FOR GEN 4 SEA PUMPS:  
625-4100  
625-4103  
625-4105  
625-4106  
625-4107  
625-4109  
625-4110  
625-4118  
625-4178

TITLE:  
HARDIN GEN 4 SEA PUMP VERSIONS

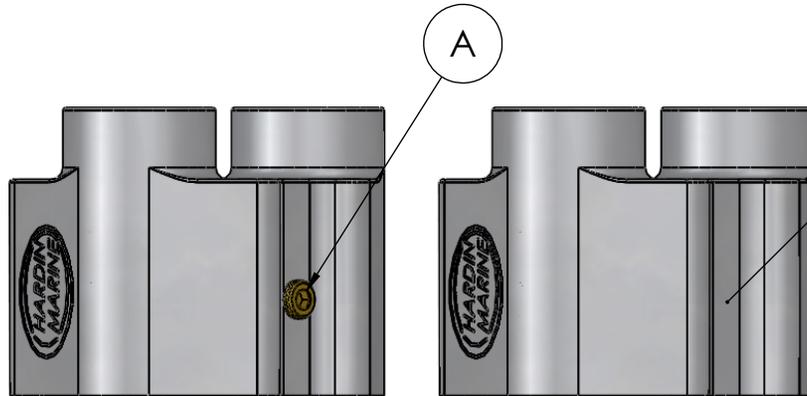
PIPE PLUG NOT USED IN GEN 2

FOR ALL HARDIN MERCURY GENERATION 4 REPLACEMENT SEA PUMPS YOU CAN IDENTIFY WHETHER YOU HAVE THE FIRST OR SECOND VERSION OF THESE PUMPS BY SIMPLY IDENTIFYING WHETHER YOUR PUMP HAS A 1/8" NPT BRASS DRAIN PLUG LOCATED ON THE UNDERSIDE OF THE PUMP HOUSING BETWEEN THE INLET/OUTLETS OF THE HOUSING, SEE FIG A. IF THE HOUSING IS OFF THE PUMP GEN 1 HAD A SLOT IN THE BODY, SEE FIG B.

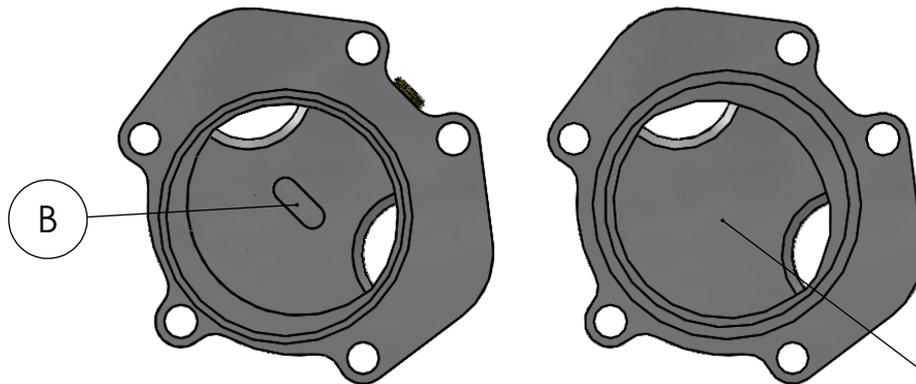
NO TAB USED IN GEN 2
